VILLAGE OF WINNETKA

Winnetka Design Review Board

Regular Meeting

Case No. 15-10-PD: Preliminary Review of Planned Development Application by Stonestreet Partners and Winnetka Station LLC, for the properties at (a) 511 Lincoln Avenue, (b) 513-515 Lincoln Avenue, (c) 710-732 Elm Street, (d) 740 Elm Street and (e) a Portion of the Adjacent Lincoln Avenue Right-of-Way

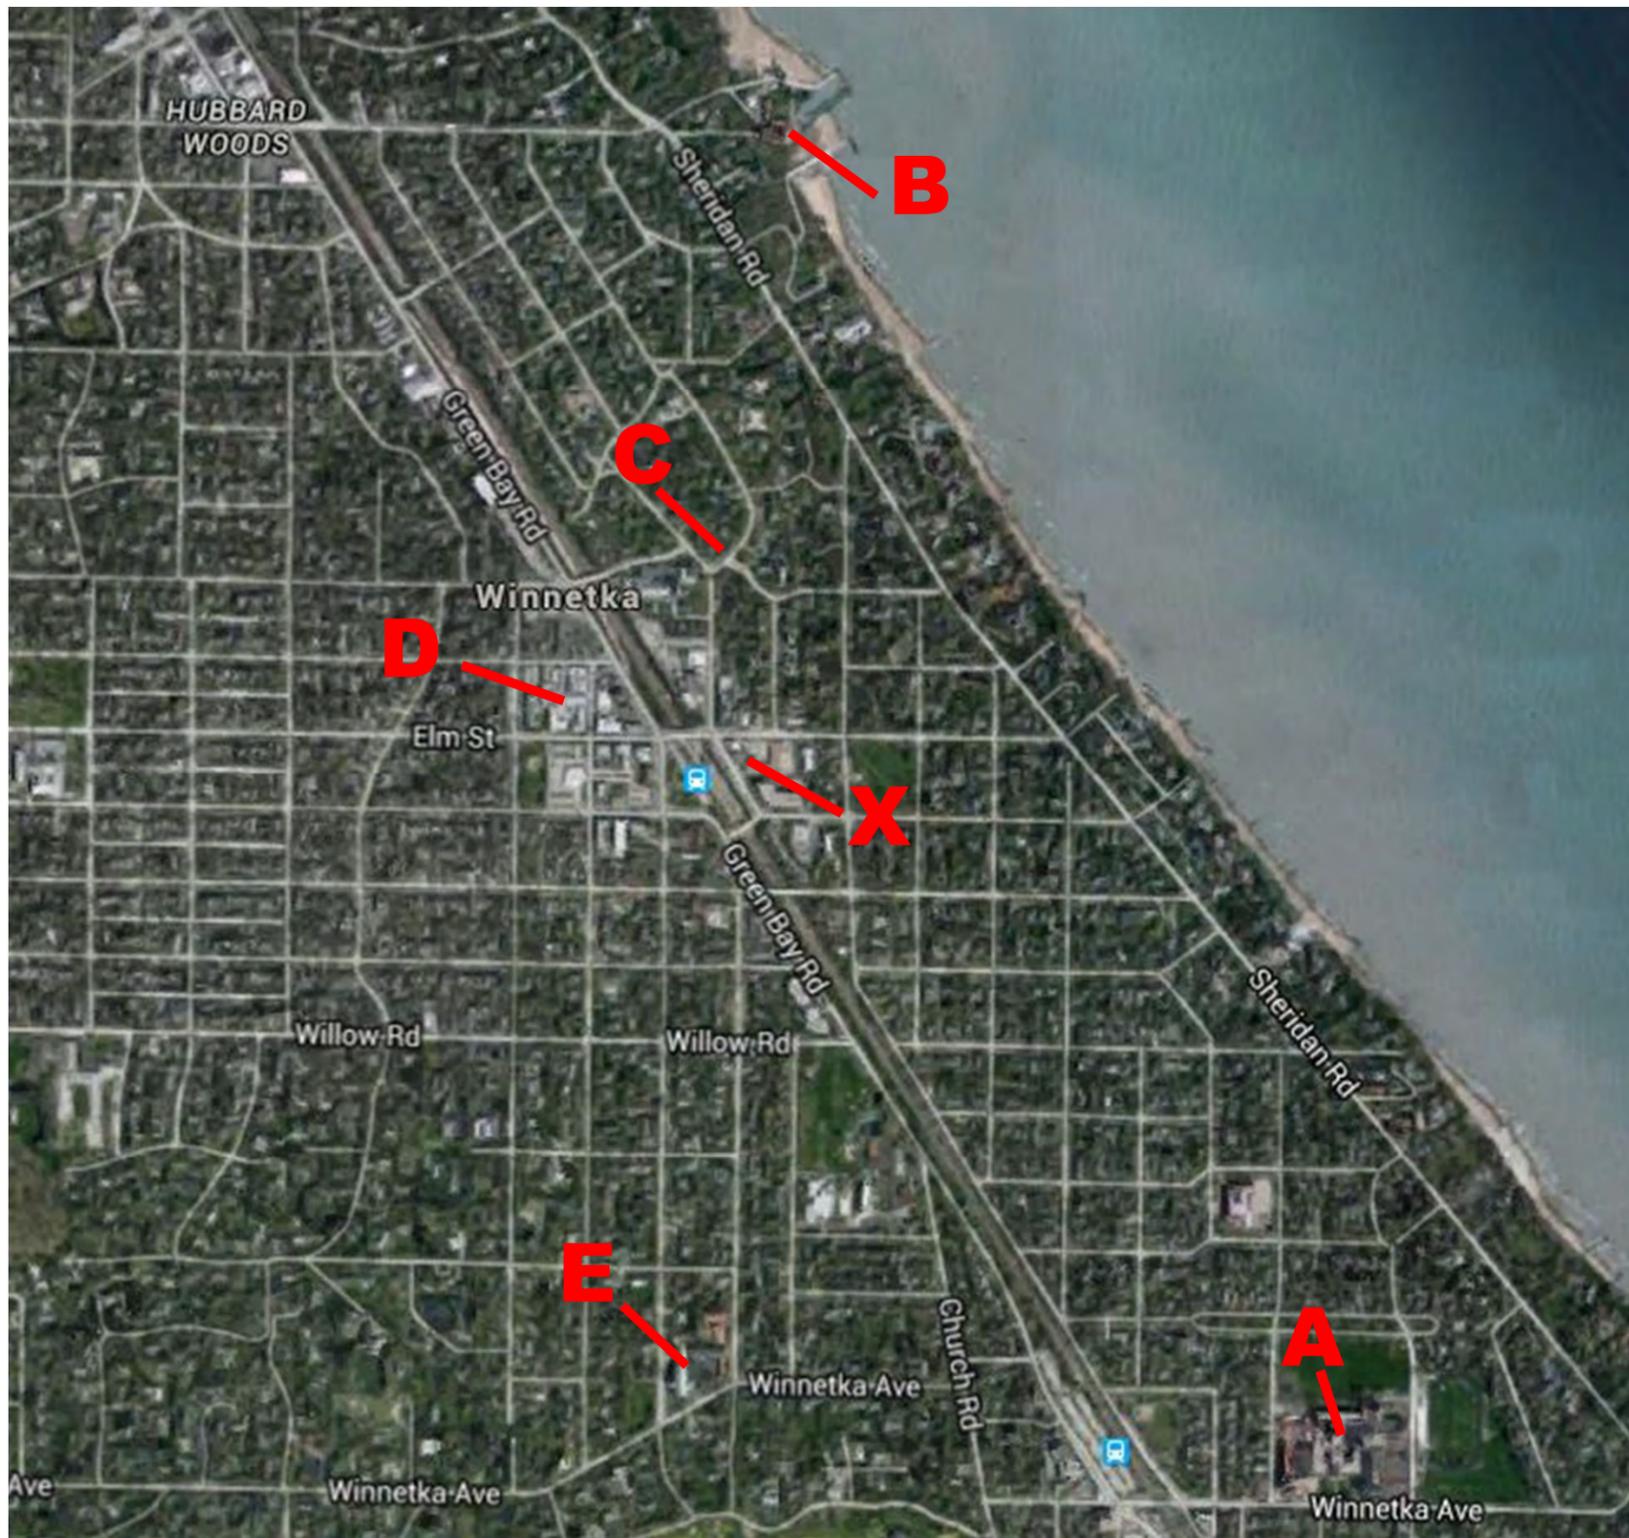
- Clarification of height of 710 Elm parking structure relative to sidewalk. (B. Dearborn)
